AGENDA
HAYDEN PLANNING COMMISSION
THURSDAY, JANUARY 12, 2023
7:00 P.M.
HAYDEN TOWN HALL – 178 WEST JEFFERSON AVENUE, HAYDEN

AGENDA ITEM TITLE: Public Hearing: Staponski Project
Site Plan – New warehouse structure
431 Capital Street, Hayden

Re: Lot 31 Valley View Business Park
Four Points Project #2200-001

LIGHTING PLAN

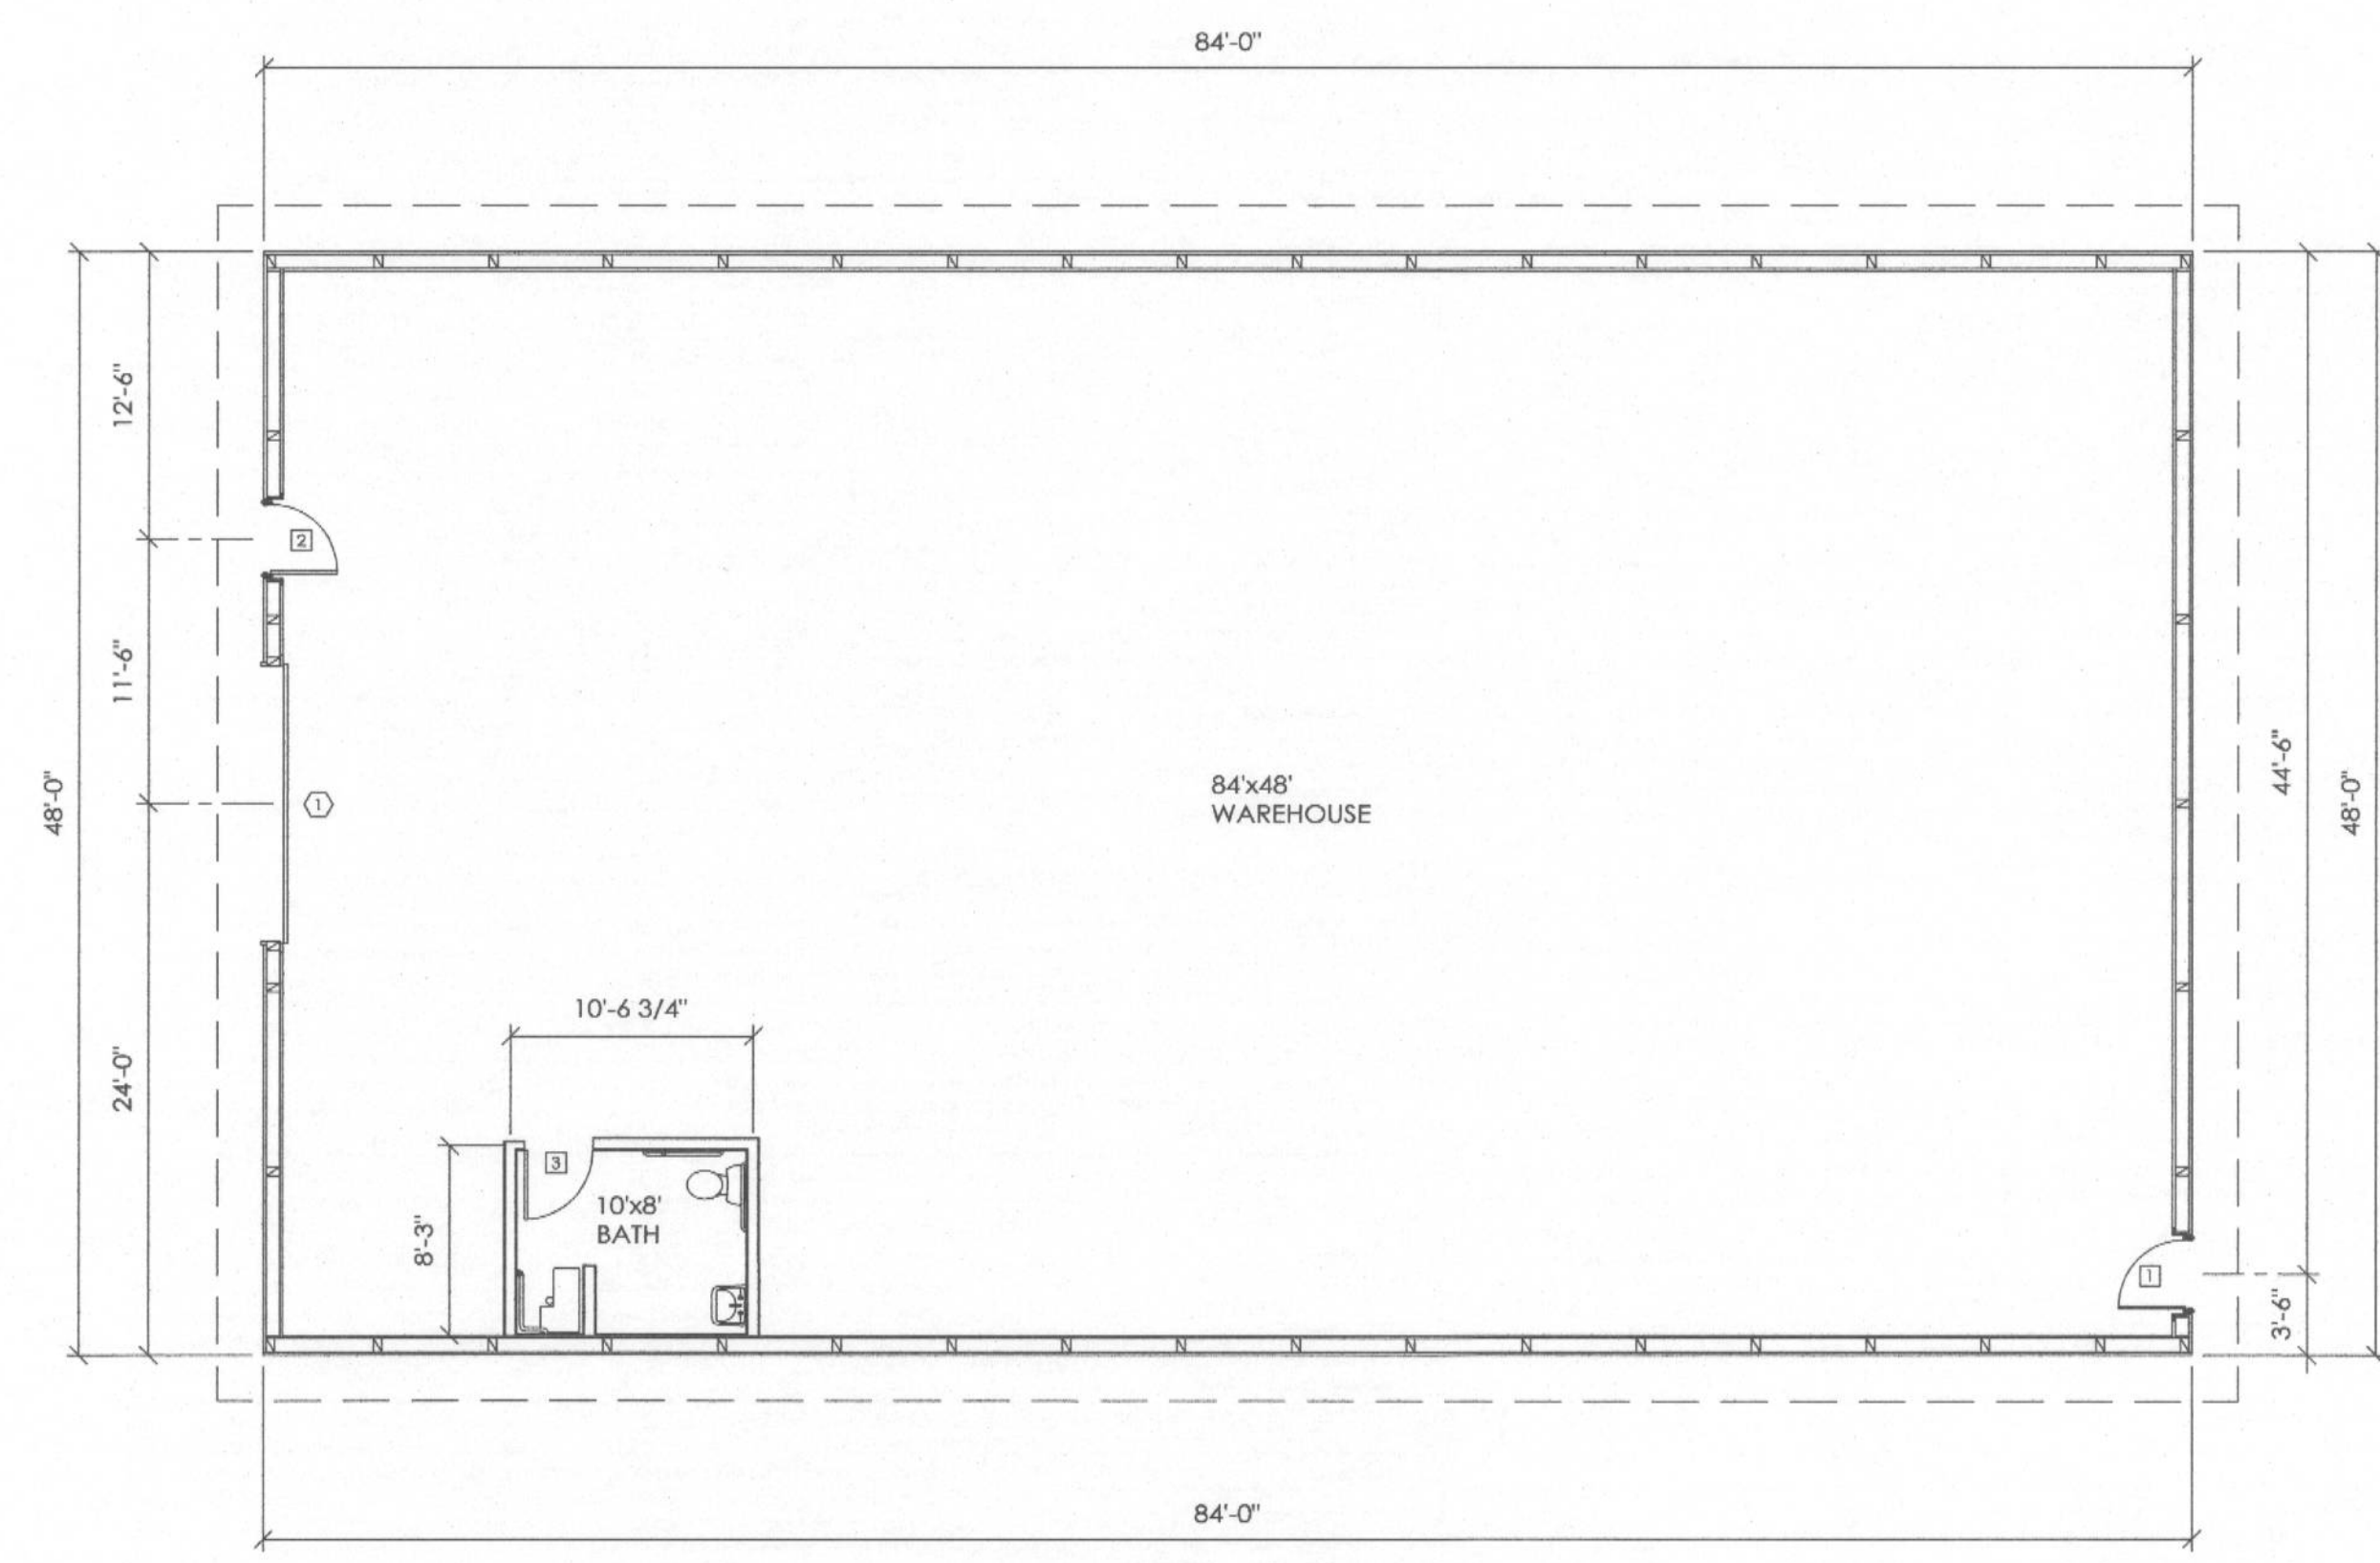
<input checked="" type="checkbox"/> <u> </u>	<input type="checkbox"/> <u> </u>	I.HL3.1 Reduce light pollution through dark sky compliant fixtures with future development. <i>Staff comment: Plans show that exterior lighting fixtures are downcast and light will not extend beyond the property boundary.</i>
---	--	---

- √ _____
9. **Lighting.** All parking area lighting shall be full cutoff type fixtures. Any light used to illuminate parking areas or for any other purpose shall be so arranged as to reflect the light away from nearby residential properties, and away from the vision of passing motorists. *Staff comment: Plans show that exterior lighting fixtures are downcast and light will not extend beyond the property boundary in accordance with this policy. The lighting fixture volume proposed is minimal, with only three (3) exterior lights to illuminate the two entrances, adjacent to the parking area, and the garage bay door.*

SOUTH ELEVATION

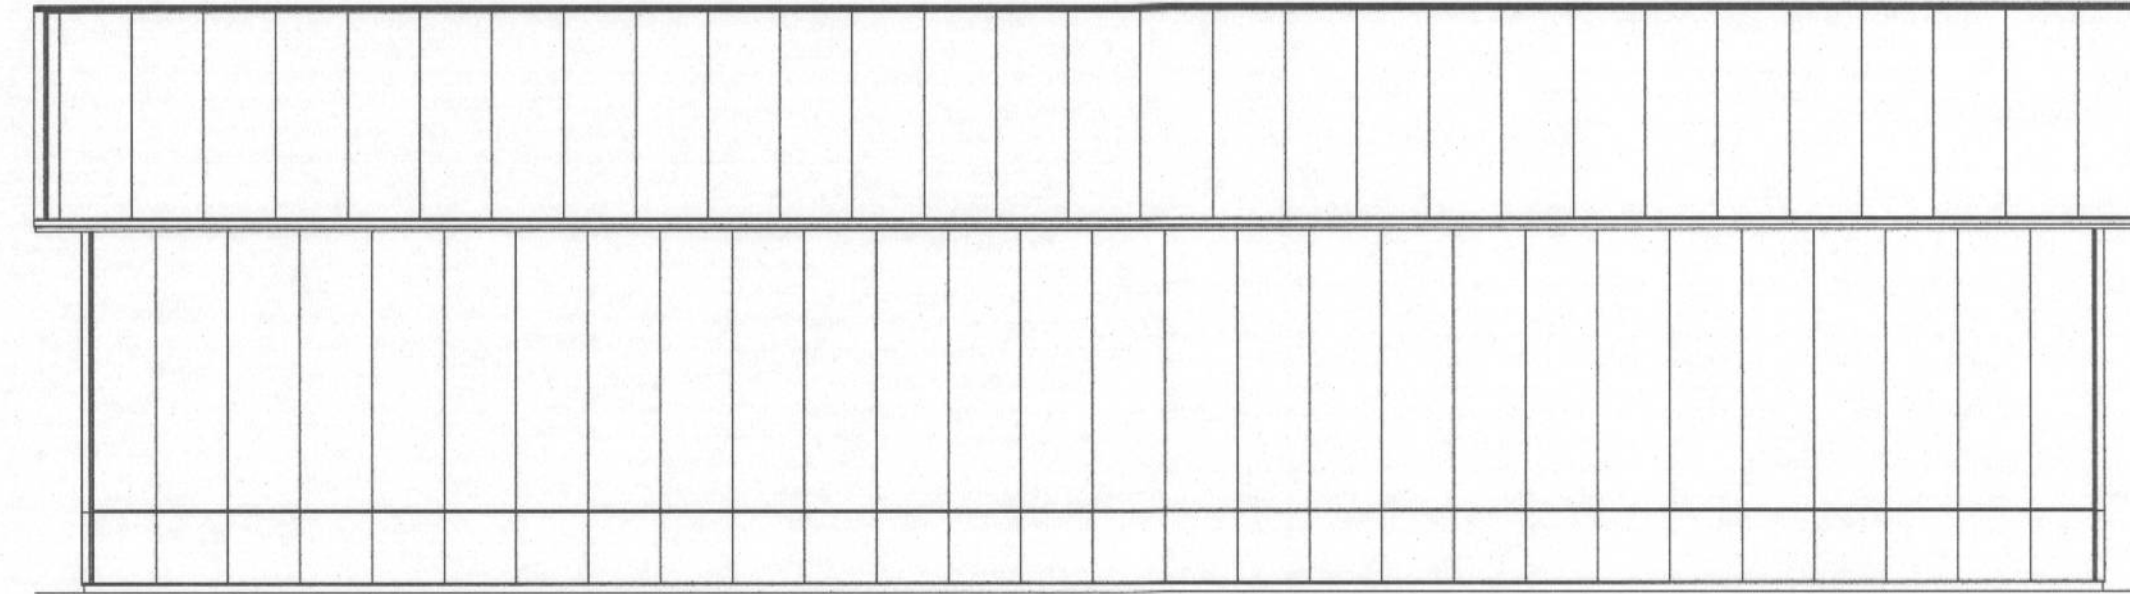
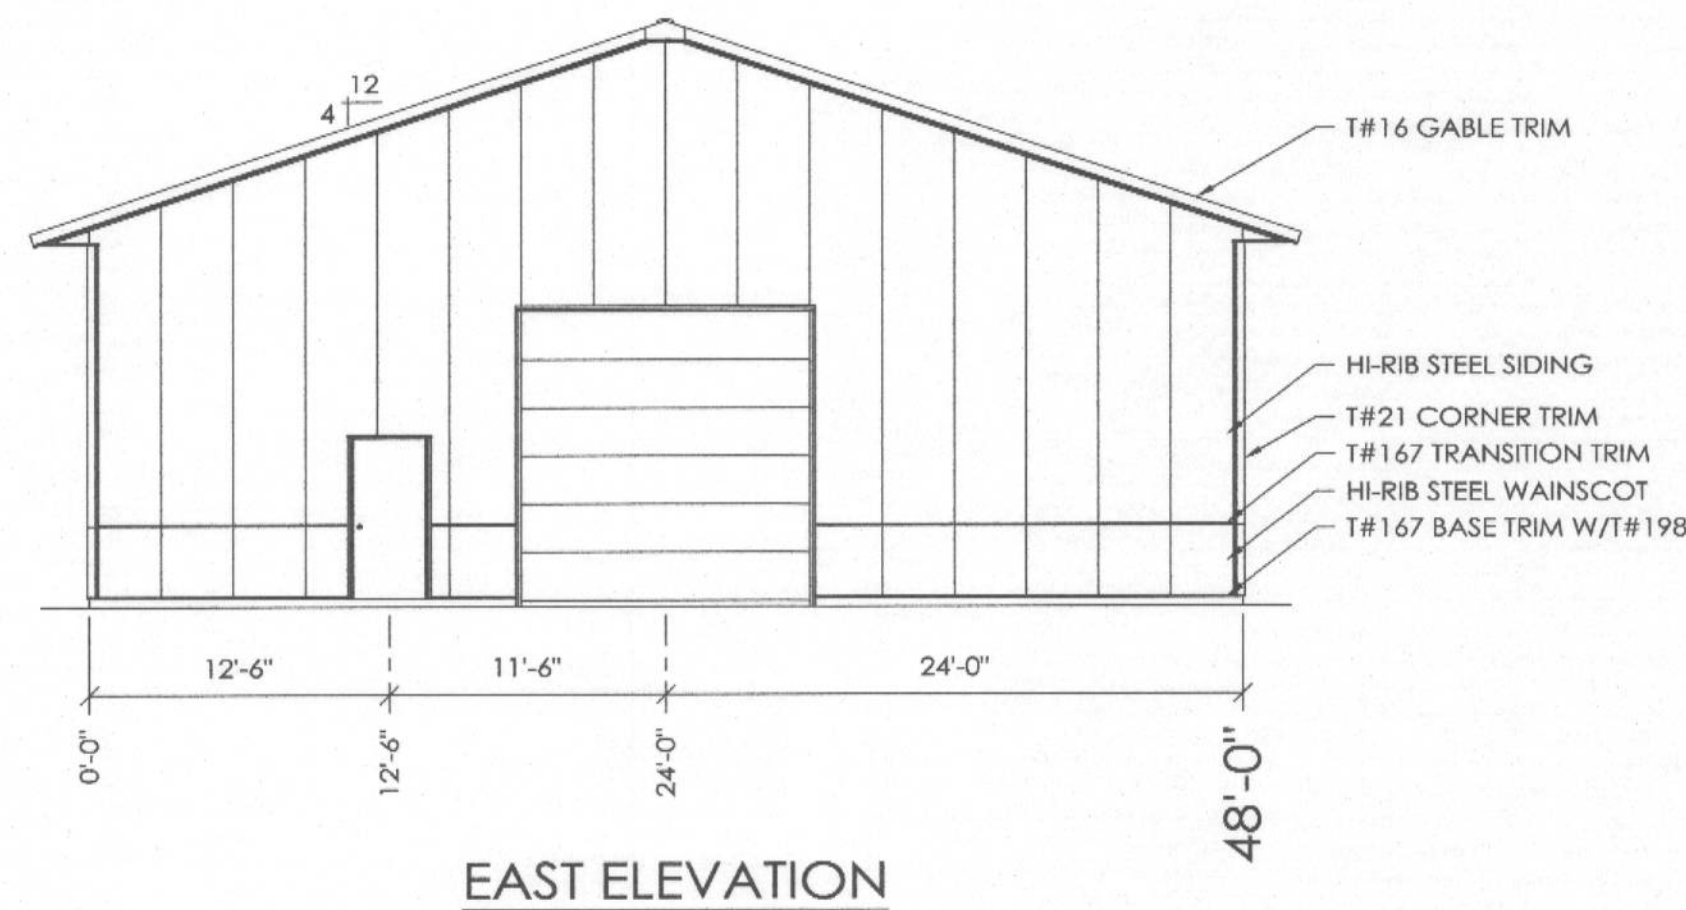
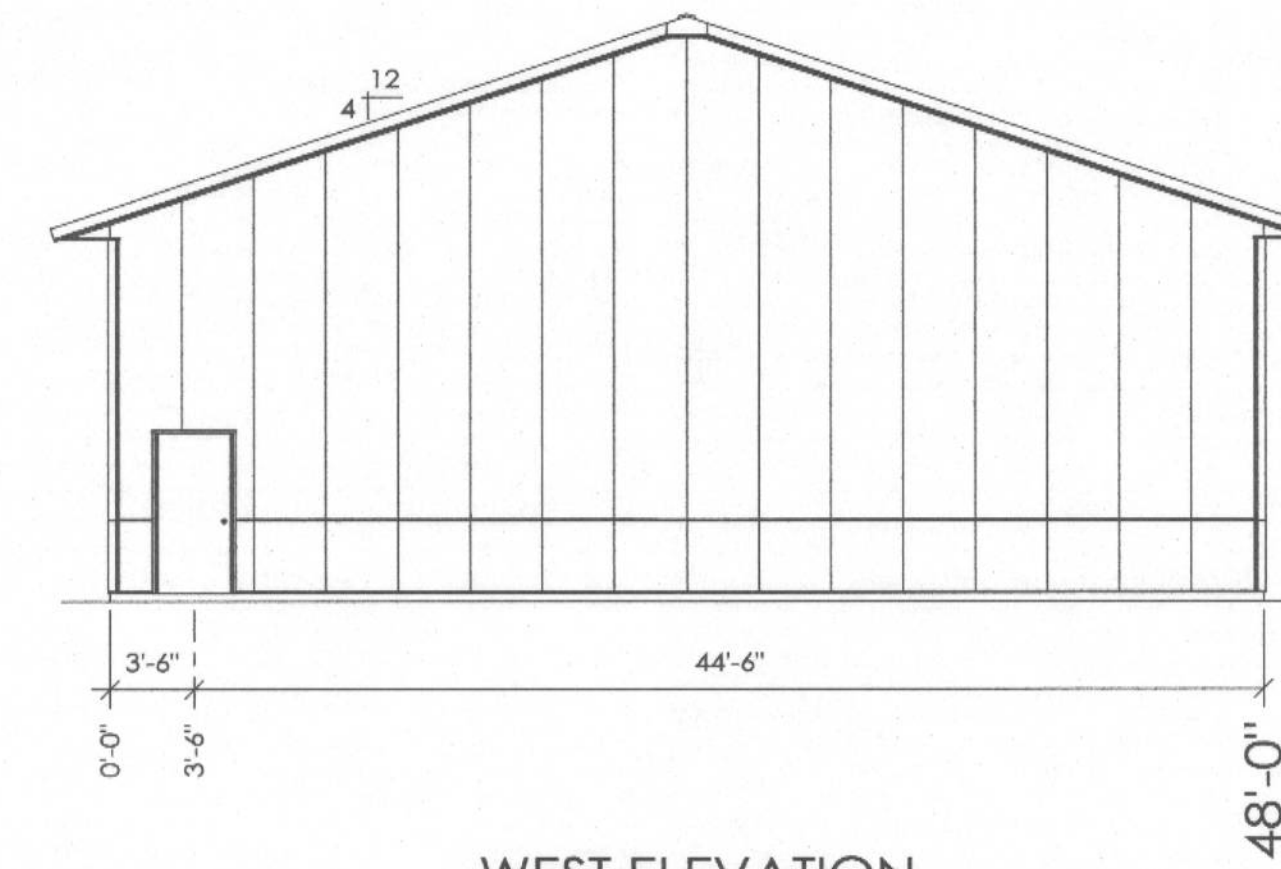
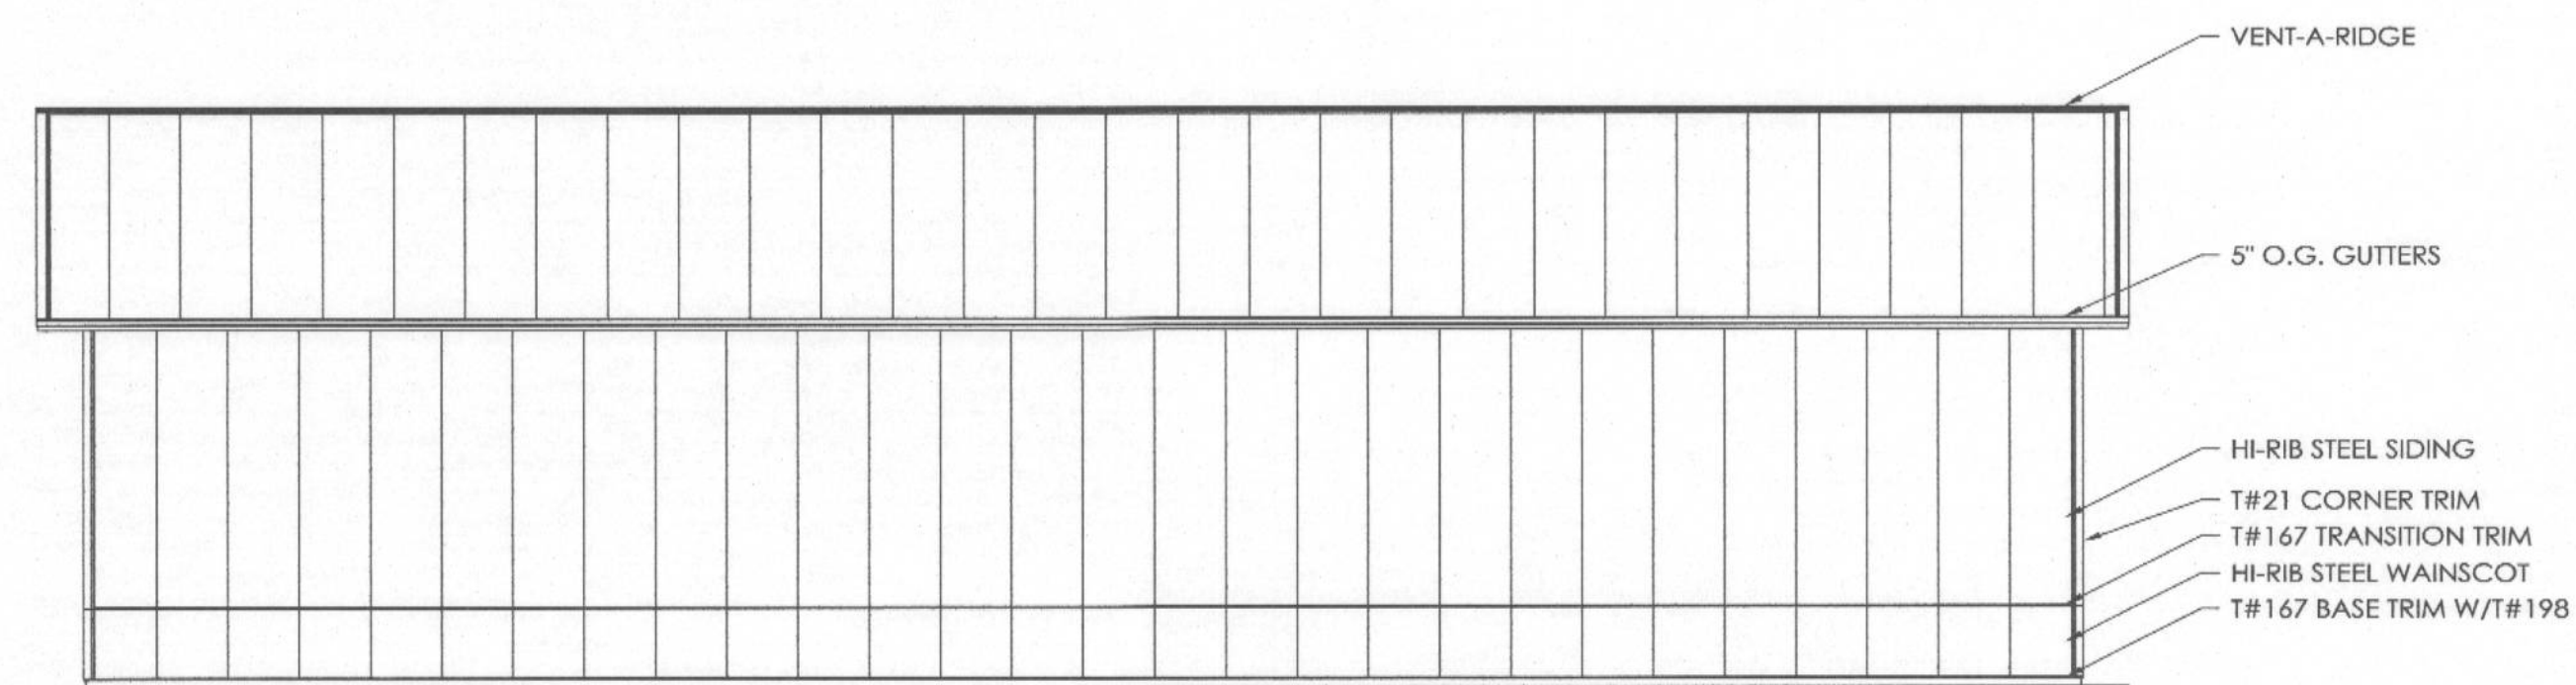
Complies		Section	Standards
Yes	No		
		E.	Industrial (I-1 and I-2) Architectural Standards.
		1.	Intent. Industrial uses shall provide the opportunity to develop industrial facilities and business parks. In addition, the following standards shall apply:
√	_____	a.	A building’s special architectural features and treatments shall not be restricted to a single façade. All sides of a building open to view by the public, when viewed from public right-of-way shall display a similar level of quality and architectural interest. <i>Staff comment: Referencing the building elevation plan included with the lighting plan, the building will have adequate openings on all sides of the building and therefore meets this standard.</i>

b.	Building massing and form.
√	_____	iii.	Loading areas shall not front any street or public right-of-way. <i>Staff Comment: Any necessary loading or unloading will occur on the interior of the building. The application does not propose loading docks and anticipate significant loading activities.</i>
√	_____	iv.	Parking requirements shall be provided to the extent possible at the rear or sides of the building. <i>Staff Comment: The parking area is located on the east (front) of the building however it is very minimal, containing only two parking spaces.</i>
√	_____	c.	Wall articulation. Walls shall not have an uninterrupted length exceeding fifty (50) feet. Pilasters, texture transitions, windows and/or stepping of the wall plane are required. <i>Staff comment: The applicant is proposing a charcoal colored wainscoting around the entirety of the beige building along with a burgundy roof. No fenestrations are proposed on the 84’ lengths of the structure.</i>
